City of Albuquerque Los Altos Pool Locker Room Remodel 10100 Lomas Blvd NE Albuquerque, New Mexico

Project Name and Address
City of Albuquerque
Los Altos Pool
Bath House Remodel

CITY OF
ALBUQUERQUE
BUILDING SAFETY DIVISION
600 Second Street N.W.
Albuquerque, New Mexico 87102

DEMOLITION FLOOR PLAN

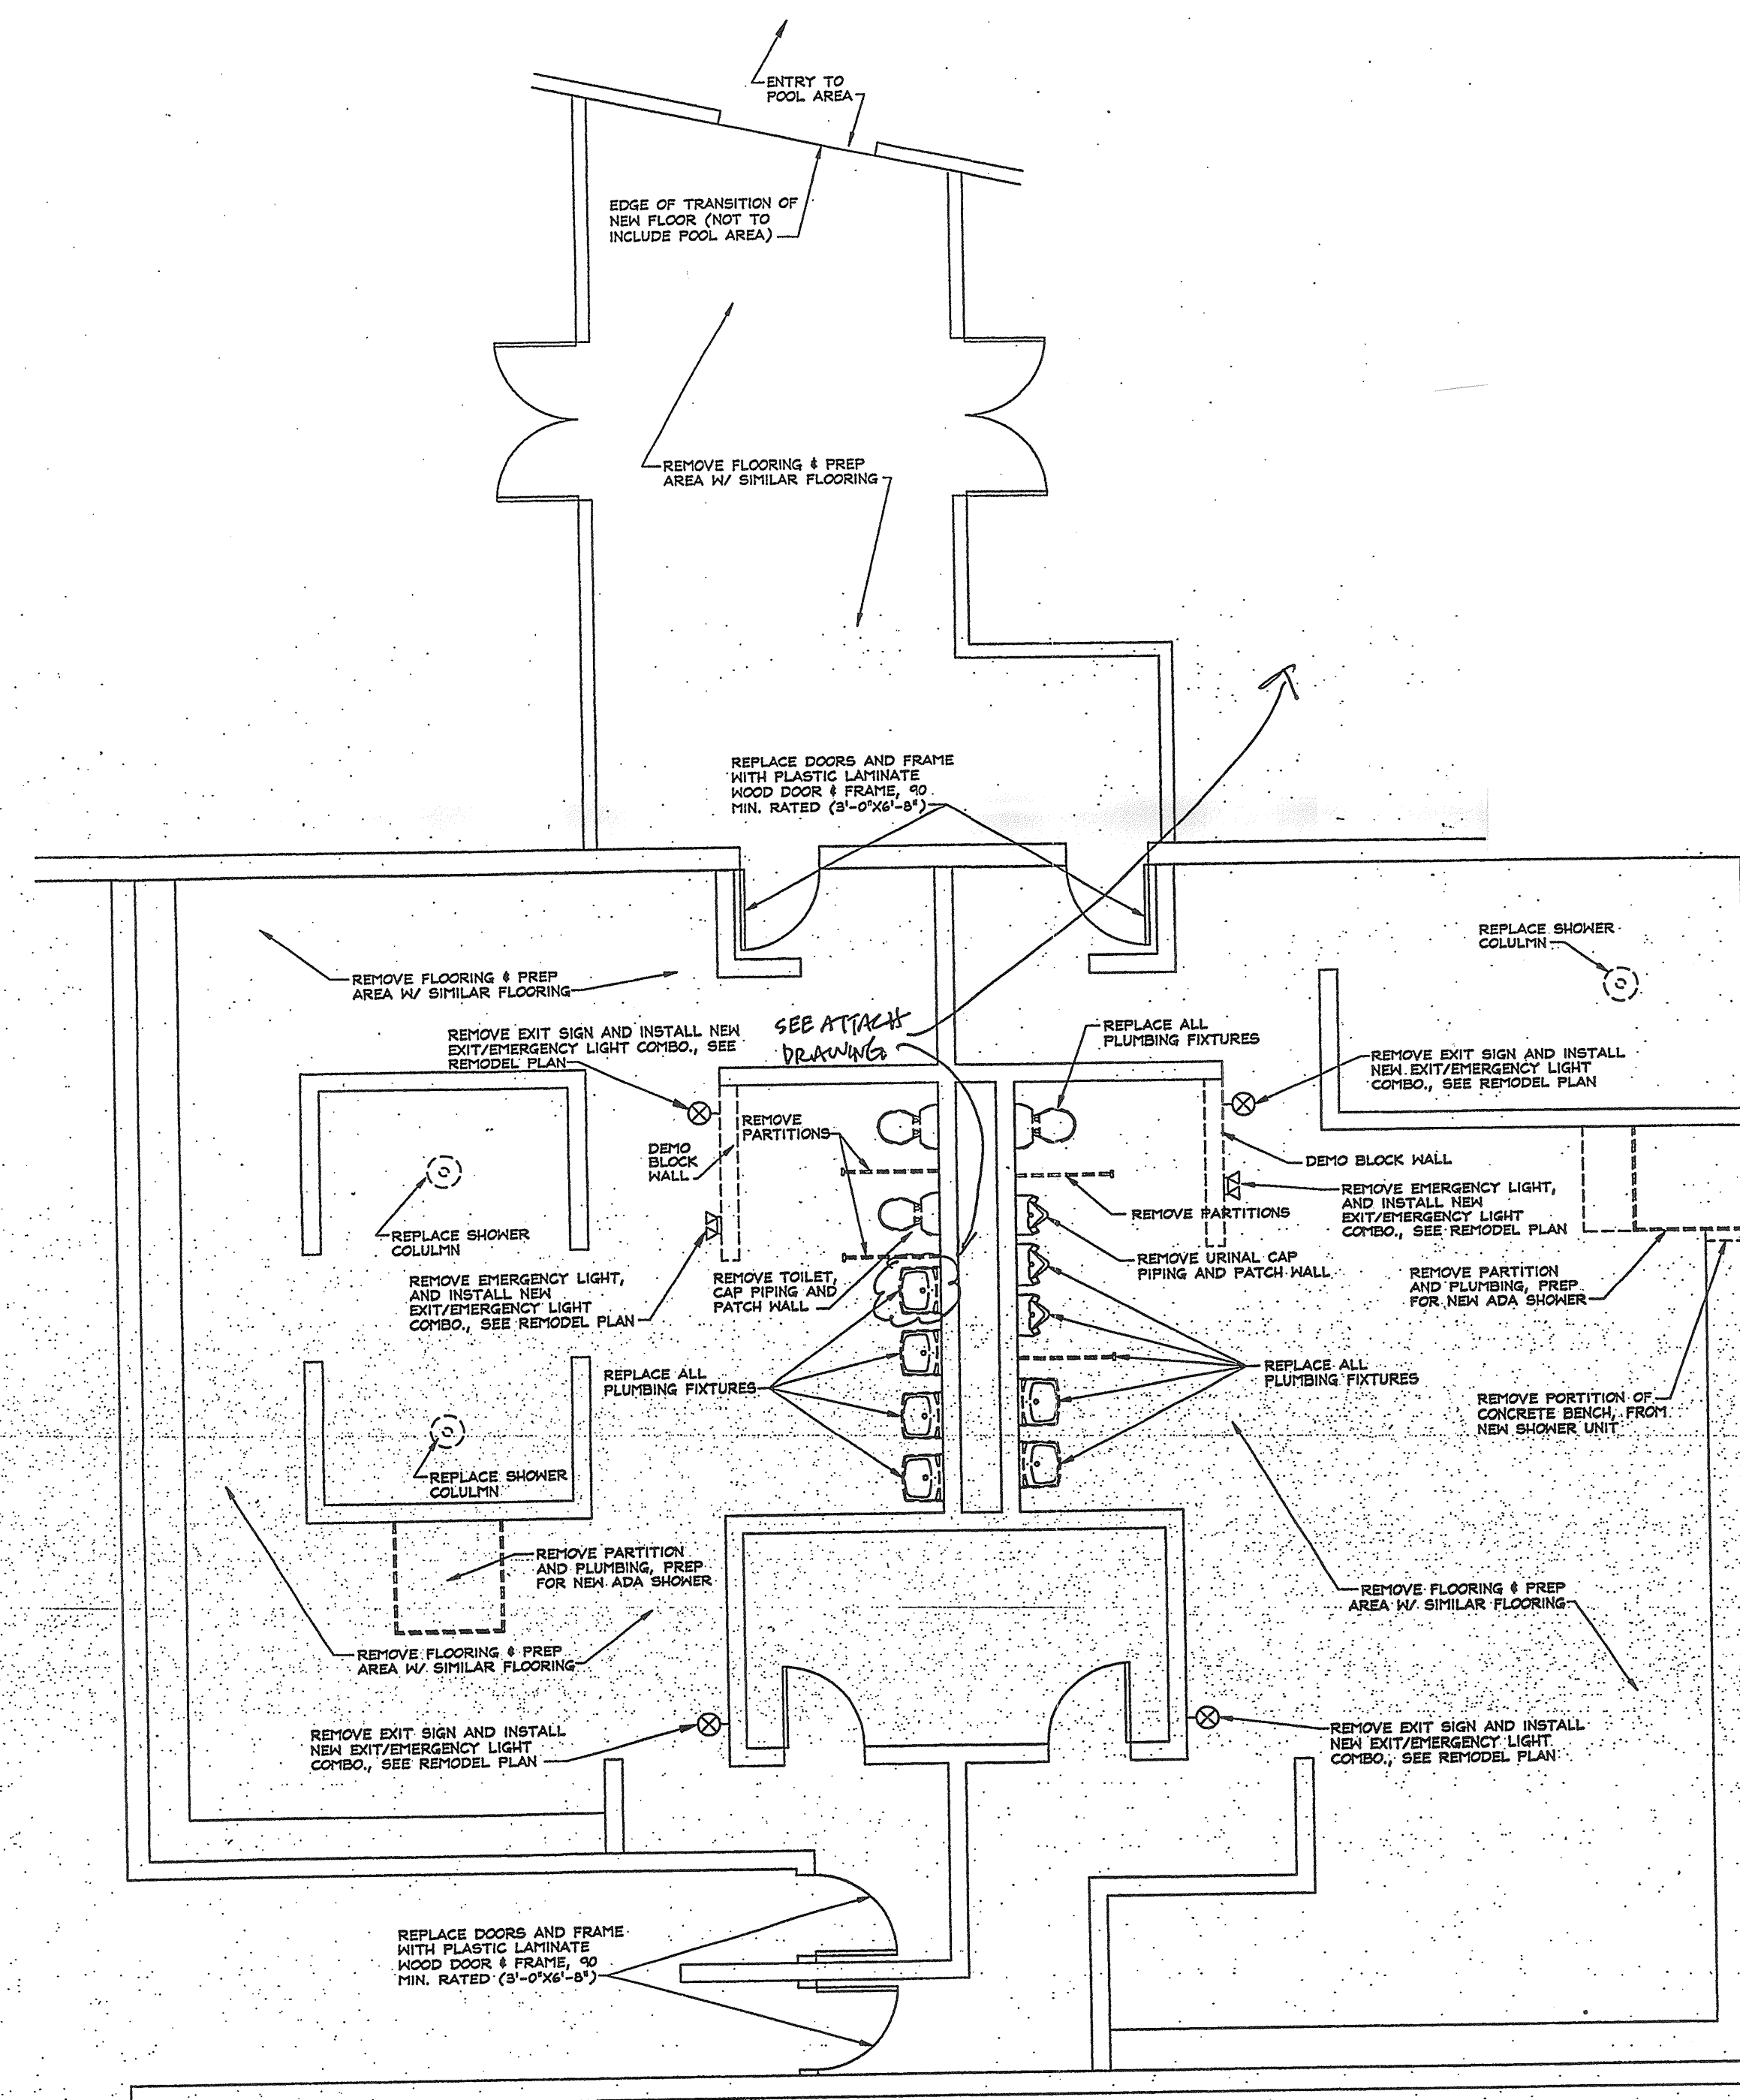
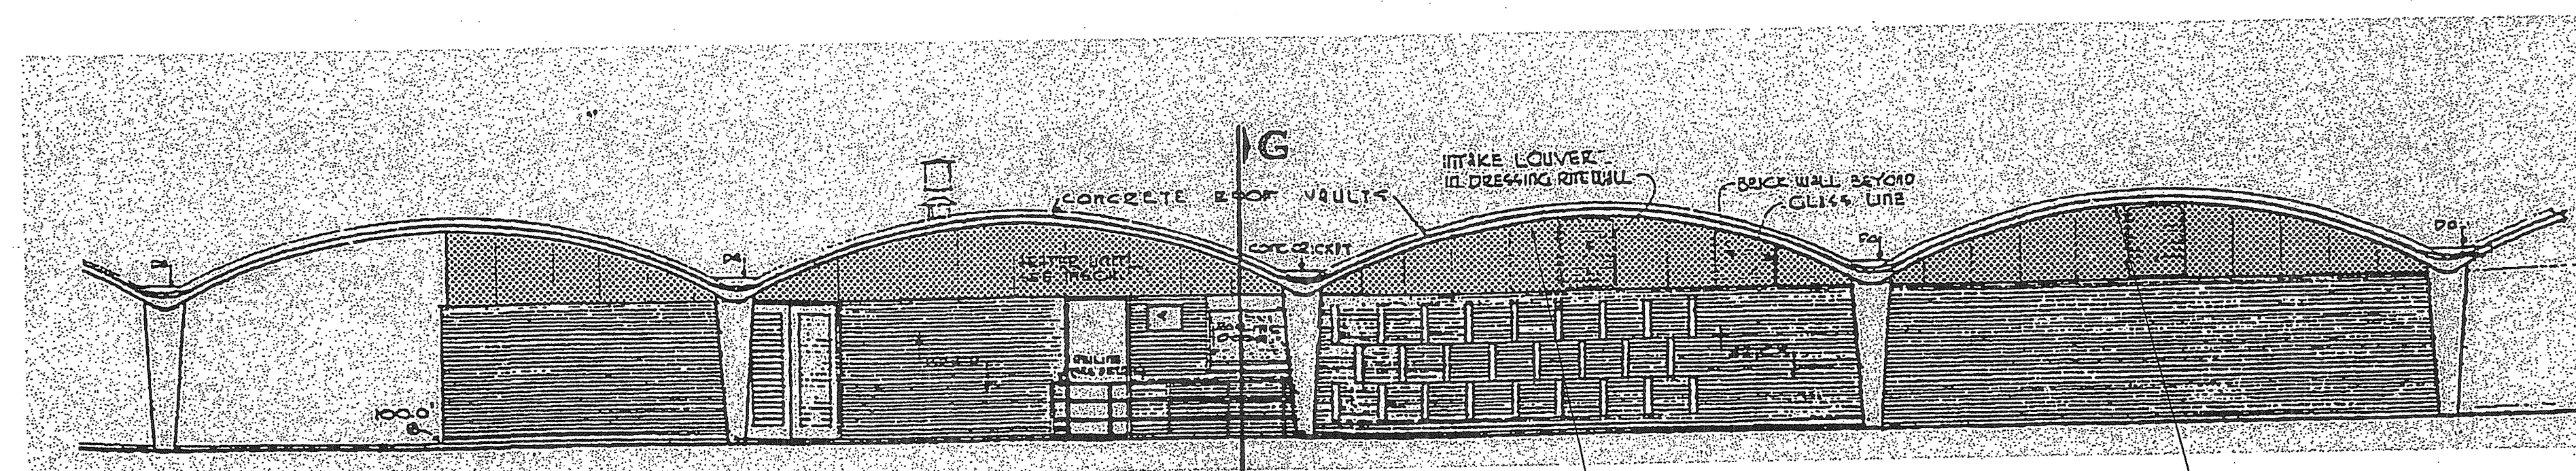
Provide energy conservation calculations for new lighting, UMC
Provide fire alarm schedule with load comparison to old system, NEC 200

Project	Sheet
Date 1/15/07	A-2
Scale varies

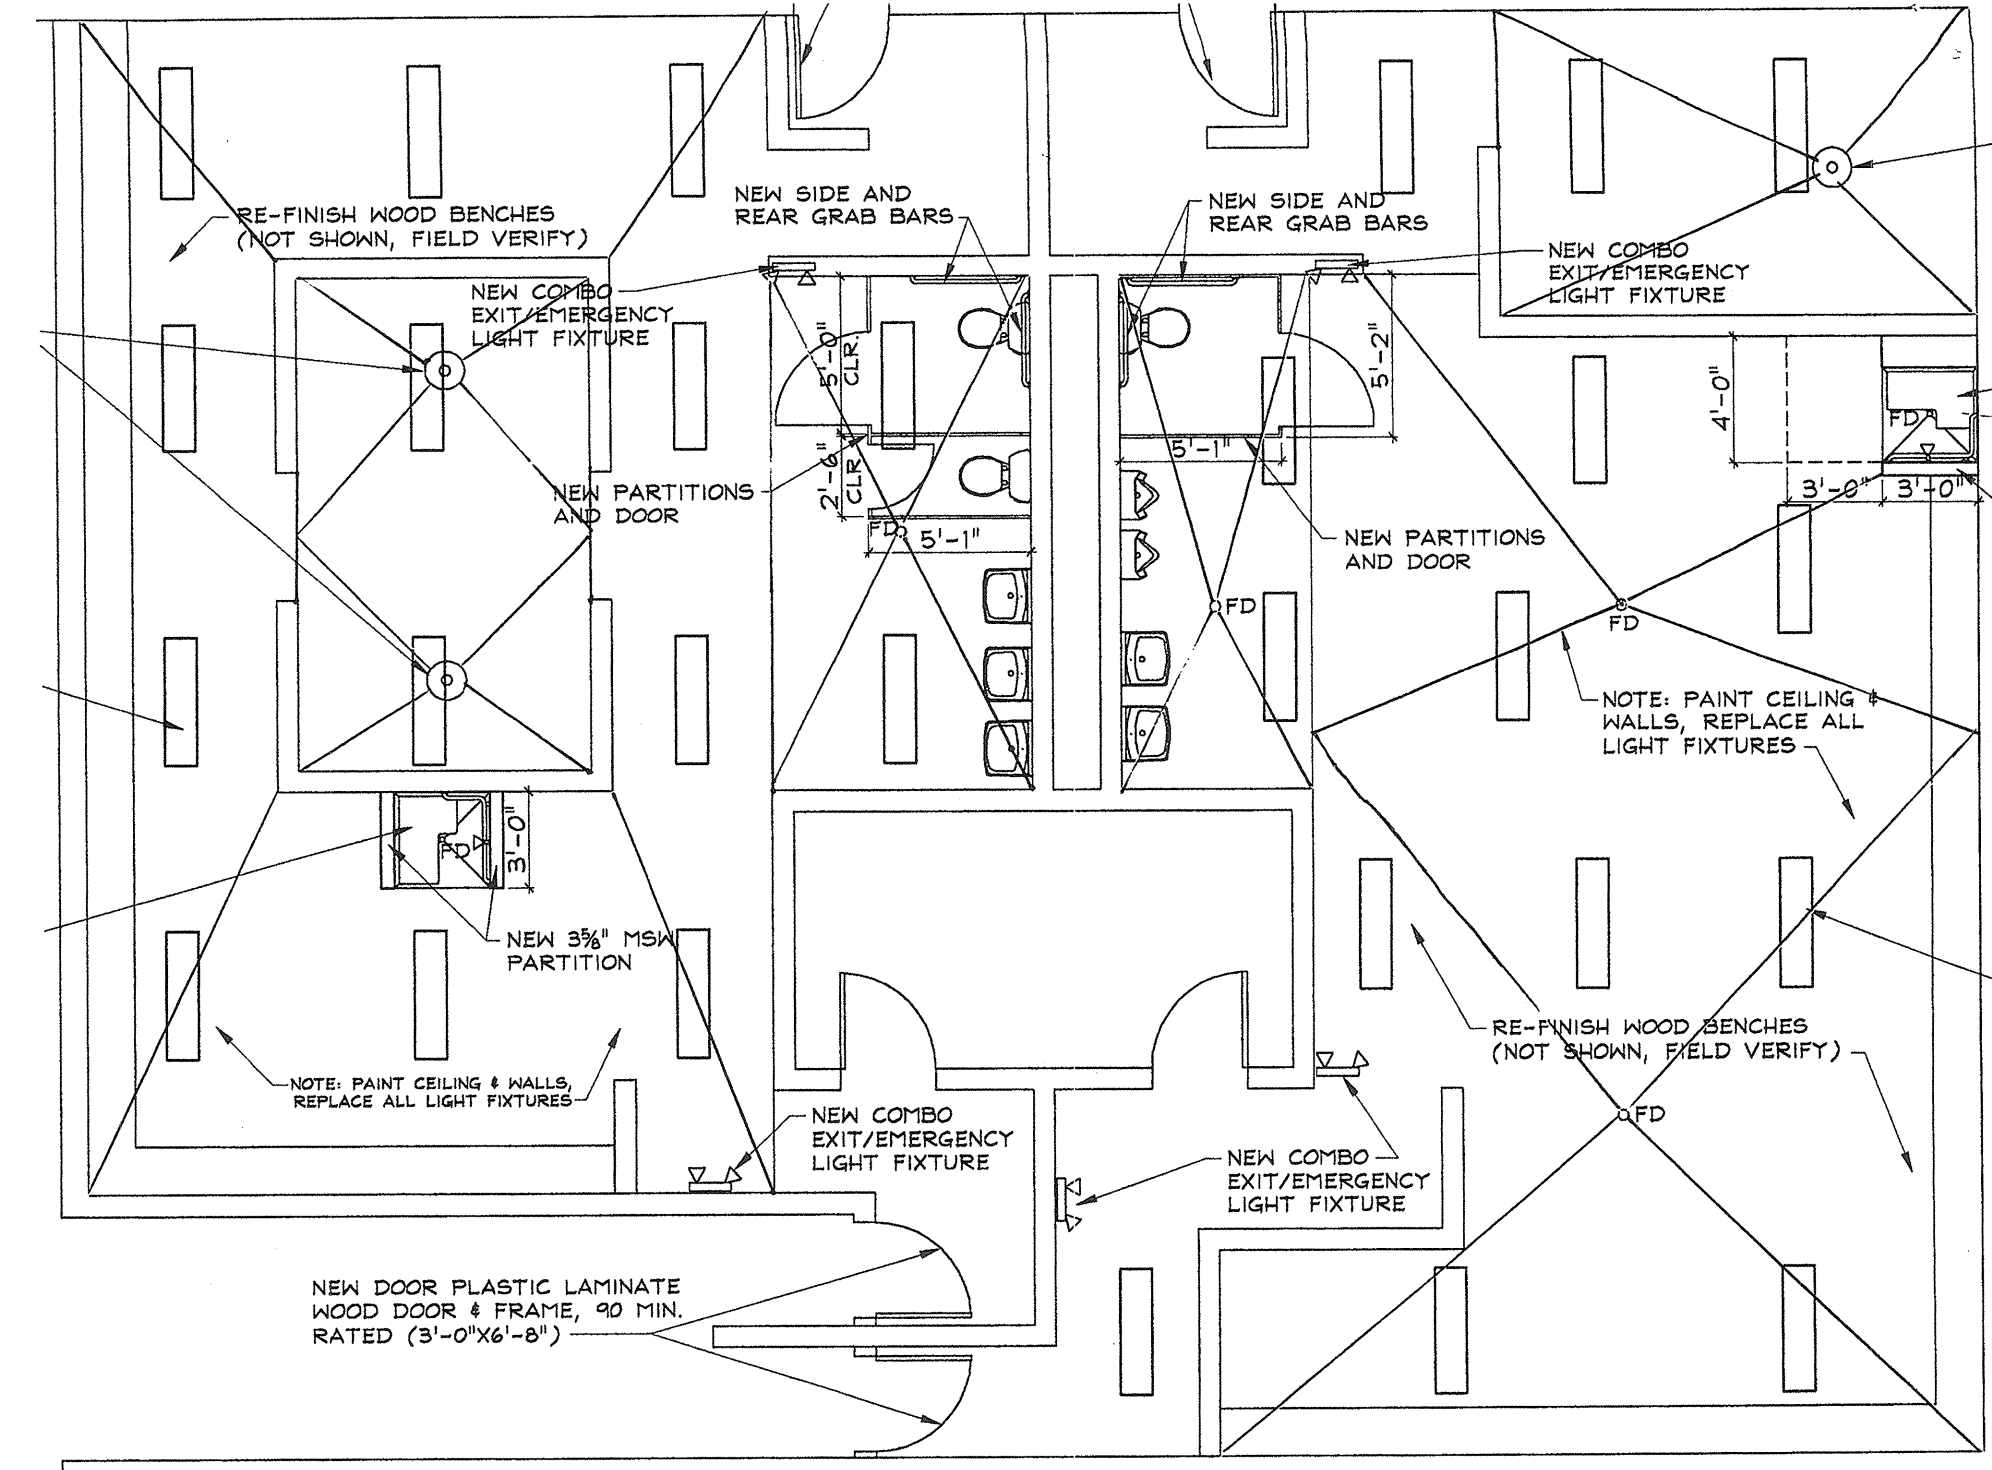
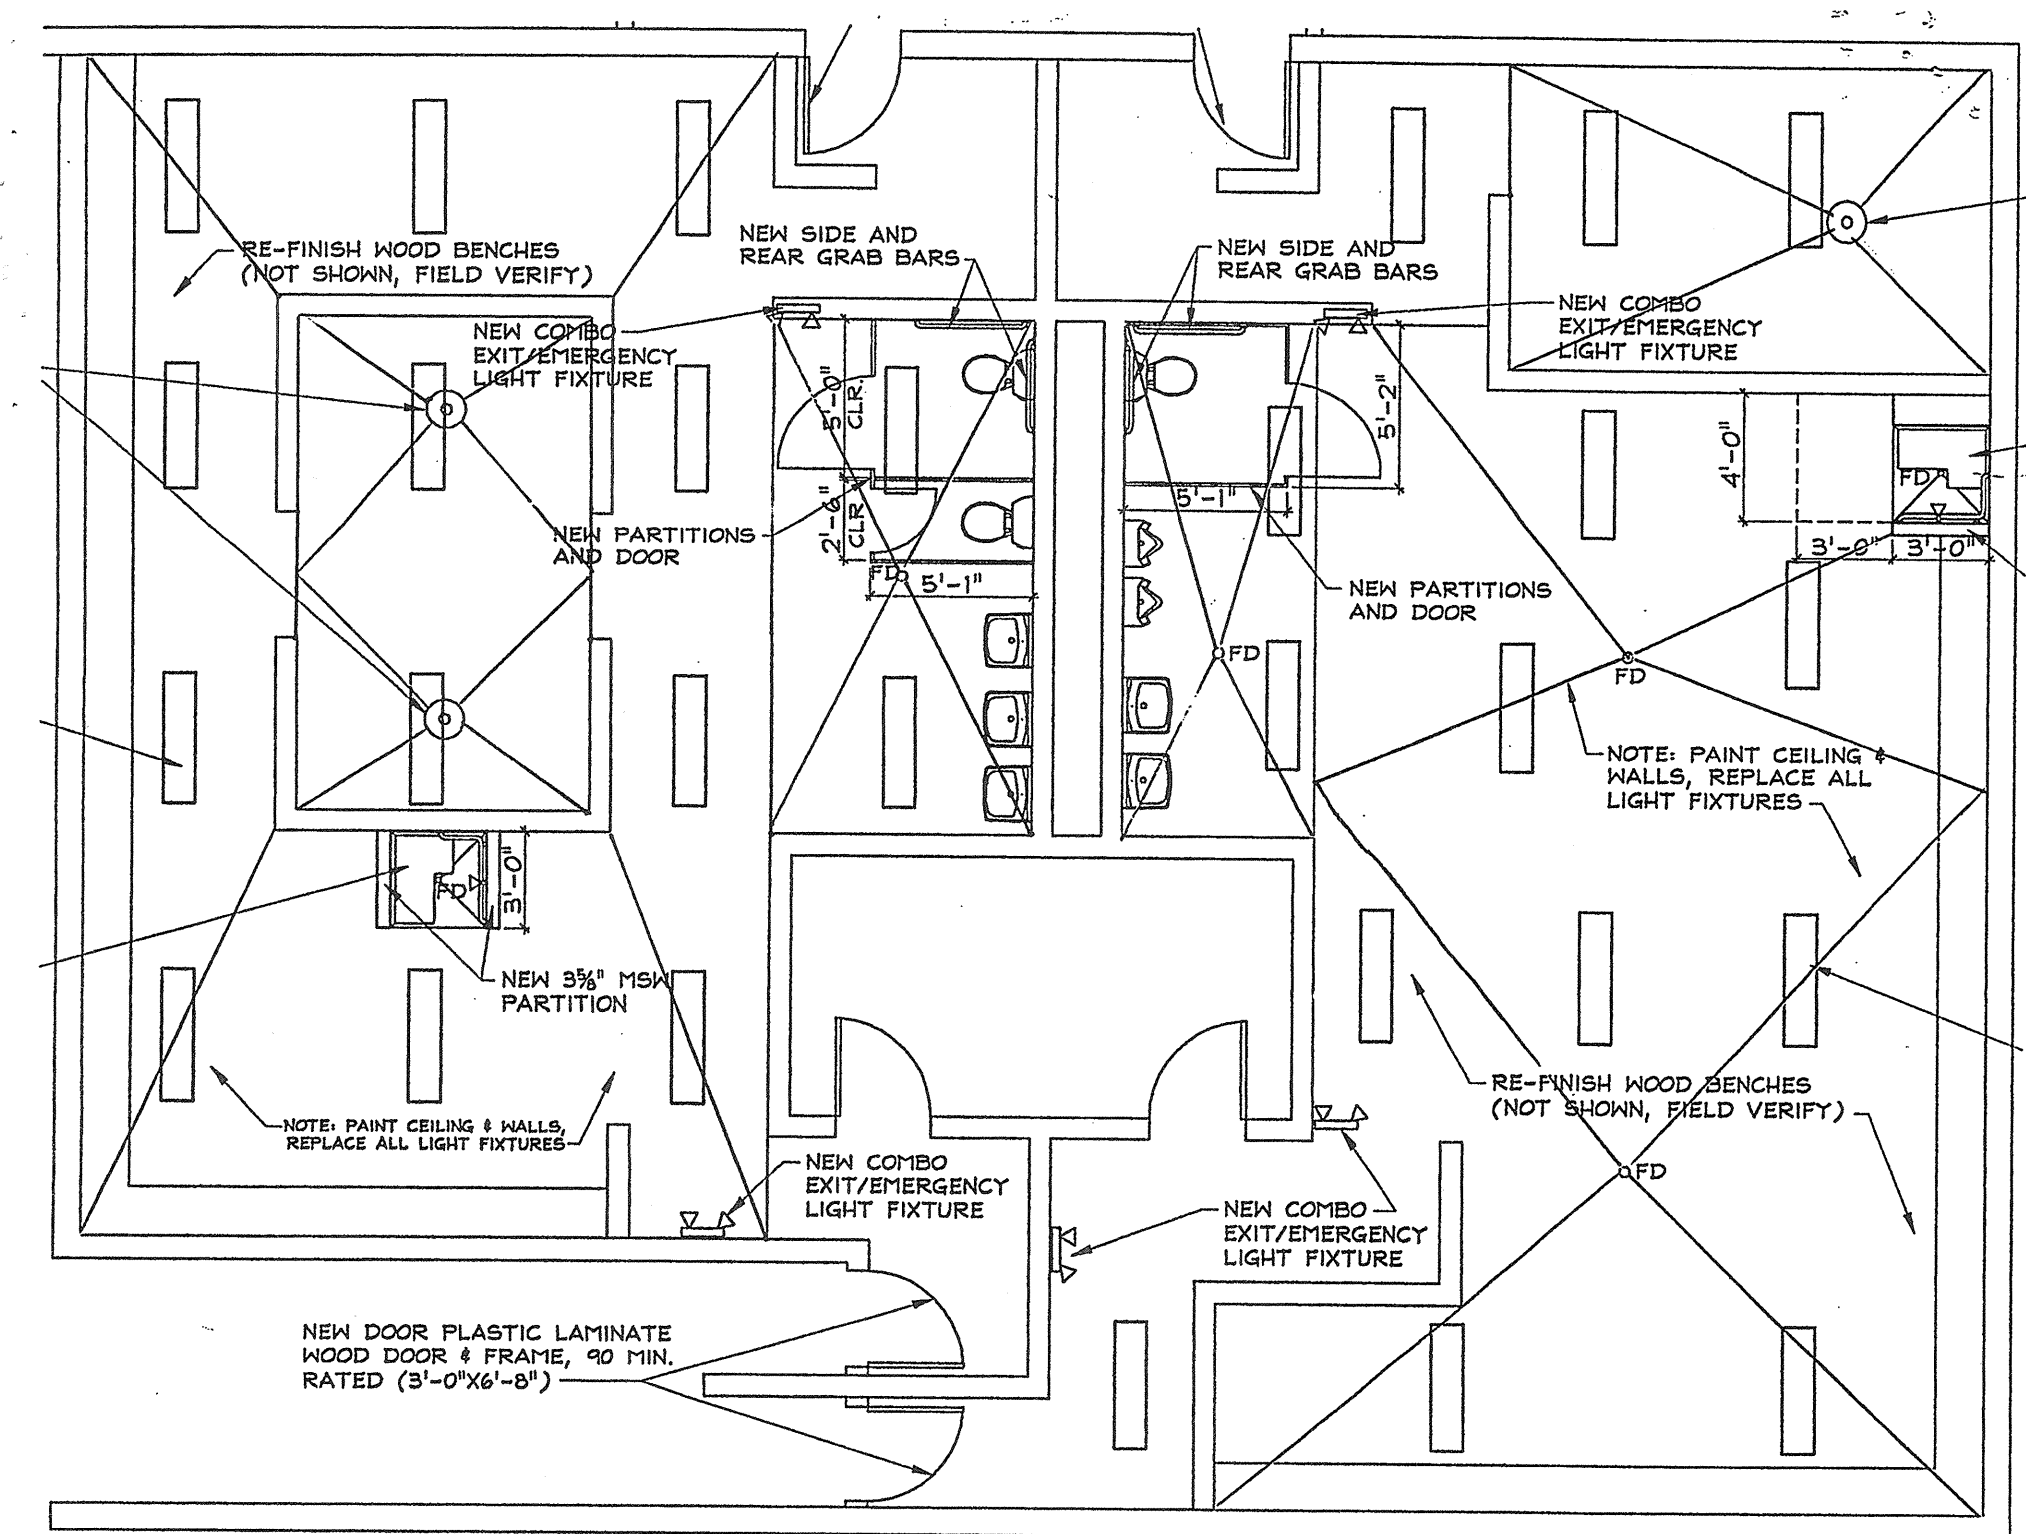
Plan Corrections approved OK J.K.G.
PLANS CORRECTIONS REQUIRED:
OK - Plans are req. to identify floor replacement, slope to drain, durable, non-slip, abrasion & slip resistant finish. Plans are req. to identify point type of holes, replacement of fixtures, ADA compliant with 2 inch maximum, number of showers, heads on new shower columns, all existing floor drains in on new area.
OK - Plans must identify that just about all showers have to be meet a minimum of 2 inch max. post occupancy load.
OK - Plans must identify required door closers & hardware & hardware mounting locations. Ref ADA reg 5 Article 3 of the City's ordinance covering swimming pools (specifically 10.3.2.4 Bathrooms 10.3.2.3 Bathrooms 10.3.2.3 Bathrooms)
